LIST OF CHANGES TO
CS760 HARDWARE

May 8, 2024

User-controlled BOOT0

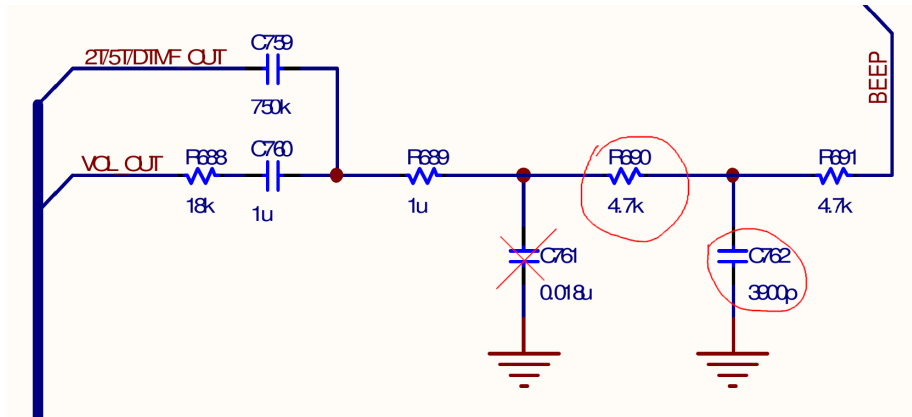
This modification is needed to allow the end user to put the microcontroller in bootloader mode by pressing the orange “alarm” button while powering on the radio. With this design, the operation of the button after the radio is powered on remains unchanged.

There is the possibility that the radio always goes into bootloader mode at power on, even if the alarm button is not pressed. In this case change R698 to 20kΩ to increase the time after which the nRESET line of the MCU is deasserted to 2ms.

Place a PNP transistor in parallel to R686 - already not fitted - connecting the base to the ALARM_KEY net (on MCU pin PE10) through a 330Ω resistor. The transistor used in the prototype is an MMBT2907, but any general purpose PNP transistor (e.g. 2N3906) should be good.

Baseband TX path

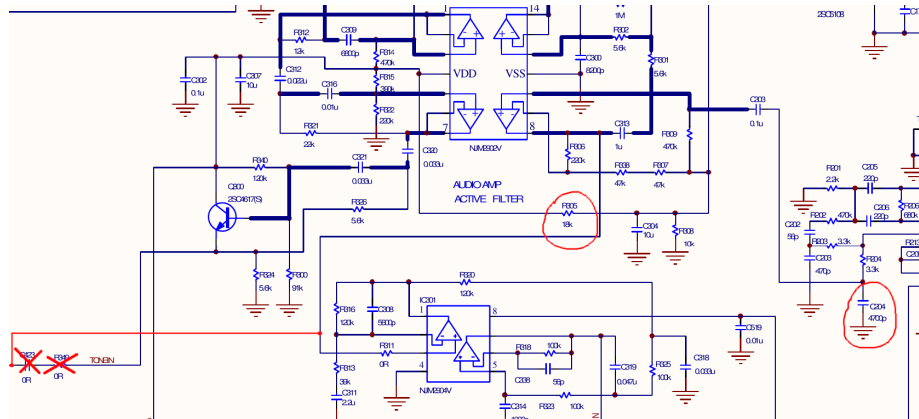
This modification moves the cut-off frequency of the lowpass filter used to smooth the DAC signal to 22.5kHz. This is required in order to have a cleaner M17 4FSK baseband signal: the original RC filter had a significant phase lag at 2.4kHz, causing an unrecoverable distortion of the baseband signal.

This modification should not have any impact on FM and DMR voice transmission. There is the possibility of a small impact on DTMF tones and speaker “beeps” in terms of an increased amplitude of the components with frequencies above 1kHz.

- Remove C761.
- Change value of R690 to 0Ω.
- Change value of C762 to 1.5nF.

Baseband RX path

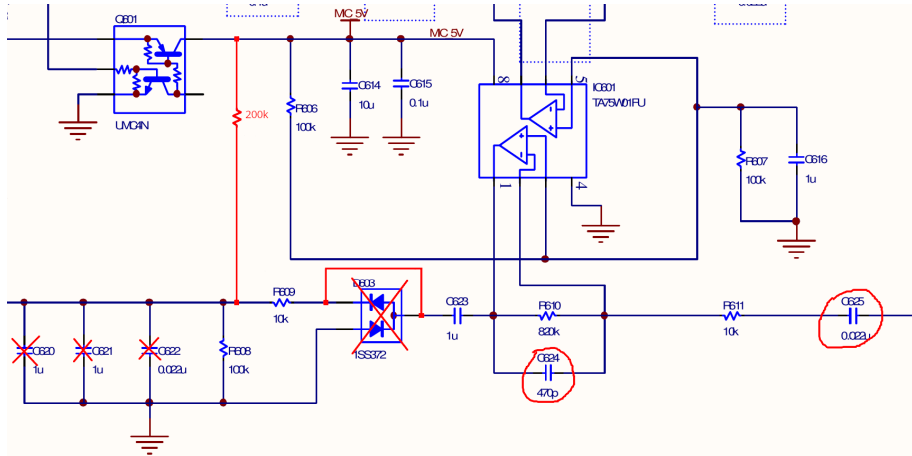
This modification is required to allow the MCU to sample the demodulated baseband signal output by the FM demodulation stage. The changes are required in order to widen the bandwidth of the lowpass filter on IC200 output to 20kHz and to bias the signal going to the ADC input to 1.65V.

This modification should not have any impact on FM and DMR voice reception. It has an impact on the decoding of DTMF and 2T/5T signalling tones (ZVEI).

- Remove C423.
- Remove R349.
- Change value of R305 to 20k Ω .
- Change value of C204 to 2.2nF.
- Connect pin 1 of IC300 (output of the first Op-Amp) **after** C423.
